# Authorized Field Change

**AFC G-03905**

**Subject:** 4200, 4300, 4400, 5000i, and 9000i Models Built Between September 23, 2002 and February 16, 2003 with Clutch Codes 11LEK, 11LEL, 11MEG, 11MEH, and 11MEJ Need a Clutch Release Roller Yoke Kit Installed

Figure 1 **Kit Components**

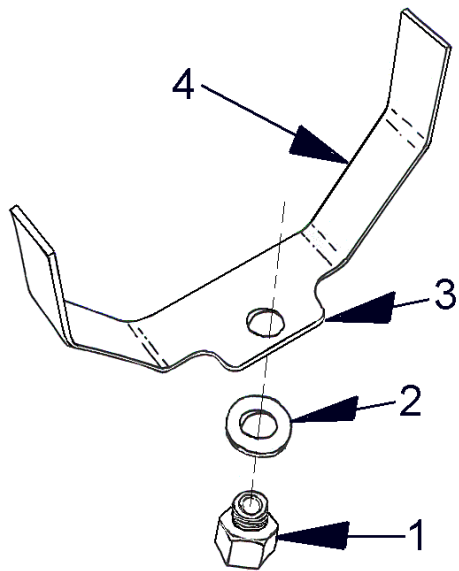
The clutch release roller yoke may cause wear when it contacts the clutch release housing resulting in linkage noise or a pulsating pedal feel when depressing the clutch pedal.

1. Remove the clutch bellhousing inspection cover.
2. Remove the clutch release bearing grease zerk fitting.
3. Install the “U” shaped clip from Kit Number 8000830R91 between the clutch release yoke and the release bearing housing with the “U” clip tab (Figure 1, Item 3) oriented rearward toward the transmission.

**Figure 2 Kit Installed as Viewed from the Engine Side**

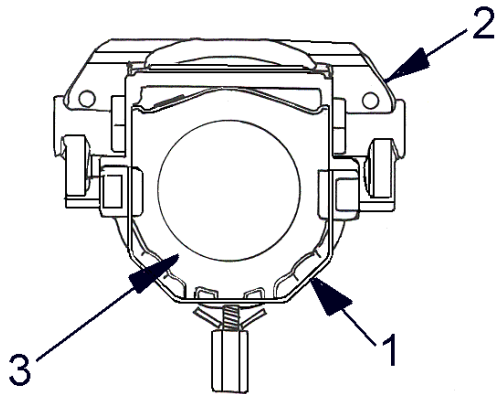
1. "U" CLIP
  2. ROLLER YOKE
  3. RELEASE BEARING HOUSING
- 
4. Install the threaded adapter and belleville washer through the "U" shaped clip into the zerk fitting hole in the release bearing housing (Figure 2). Tighten to 20 to 25 Lbf-ft (27 to 34 Nm).
  5. Install the grease zerk fitting into the threaded adapter.
  6. Reinstall the inspection cover to the clutch bellhousing.
